**REPORT ON INDEPENDENT  
ANALYSIS AND ADVICE  
REGARDING THE SAFETY CASE**

# **Tihange 2**

## **Reactor Pressure Vessel Assessment**

**Electrabel**  
GDF SUEZ

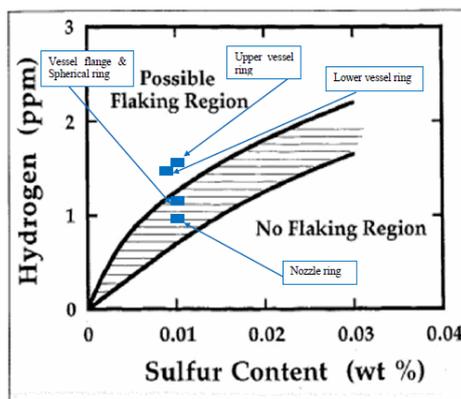
The following chart illustrates the above statement specifically regarding the influence of the concentration of sulphur—one of the most important chemical parameters for hydrogen flaking—in the forged pieces of the Tihange 2 RPV (the actual amount of sulphur measured by Krupp is lower than the specified value of 0.02 wt%). This led AREVA (in the 1980's) to specify a maximum hydrogen concentration of 0.8 ppm to avoid the risk of hydrogen flaking.

Although the chart above (R. J. Fruehan, *Iron & Steelmaker*, 1997)—adapted to the specificities of the Tihange 2 RPV—is mainly indicative, both the upper and lower shells of the Tihange 2 RPV shell are in the possible flaking region.

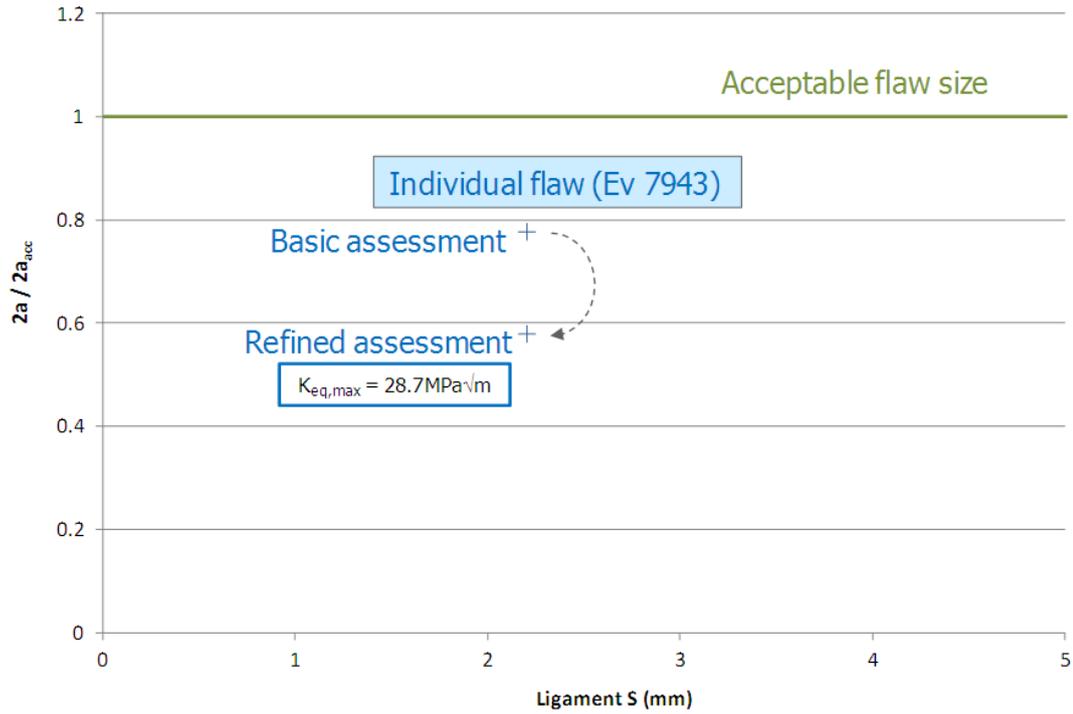
SNL has shown that considering such flaws in isolation can be non-conservative for some configurations of closely-spaced flaws. SNL recommended that flaws that have been deemed acceptable in isolation by the Project Team be reassessed in light of the effect that neighbouring flaws may have on them. In order to address this concern, the Project Team assessed the influence of the environment on ungrouped flaws through 3D analysis of the two individual flaws closest to the maximum available size. One result for Doel 3 is shown in the picture below where the refined assessment shows a significant additional margin:

**The SCP Review Team agrees with the Project Team approach to address the concern identified by SNL.**

In light of the results, SNL concludes that the Project Team approach is reasonable and that it will ensure the adequacy of the methodology. The SCP Review Team agrees with this conclusion.

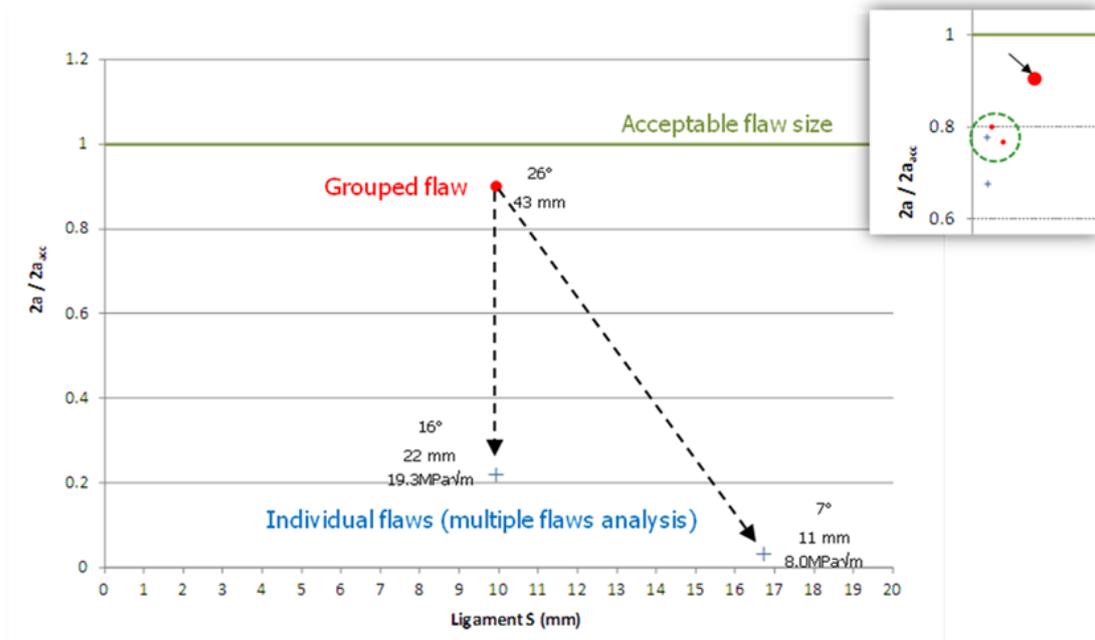
SCP Review Team thoroughly challenged the Project Team regarding the modified ASME XI flaw assessment methodology. The most important concerns of the SCP Review Team were about how to conservatively apply the proposed grouping criteria and how to take into account the effect of the surrounding flaws on the isolated flaw.

The Project Team has clearly demonstrated that the only cases for which this question was relevant were acceptable. The relevant cases are the ones in which the flaws (grouped or isolated) are close to the maximum allowable size before facing a crack initiation risk, according to the ASME values. For the flaws close to this limit value, calculations have been made by the Project Team to quantify the impact of the grouping criteria and the surrounding flaws. To perform those calculations, the grouped flaws have been un-grouped. The set of un-grouped flaws has been evaluated through 3D calculations. The results were completely satisfactory, showing that the grouping criteria used were acceptable and offered a large margin versus allowable size, as shown in the graph below.

Similar 3D calculations were performed for the most critical isolated flaw, with similar results. The potential lack of conservativeness due to the neglected influence of the surrounding flaws on the calculated flaw, was largely compensated for by the over-conservativeness of the flaw grouping methodology.
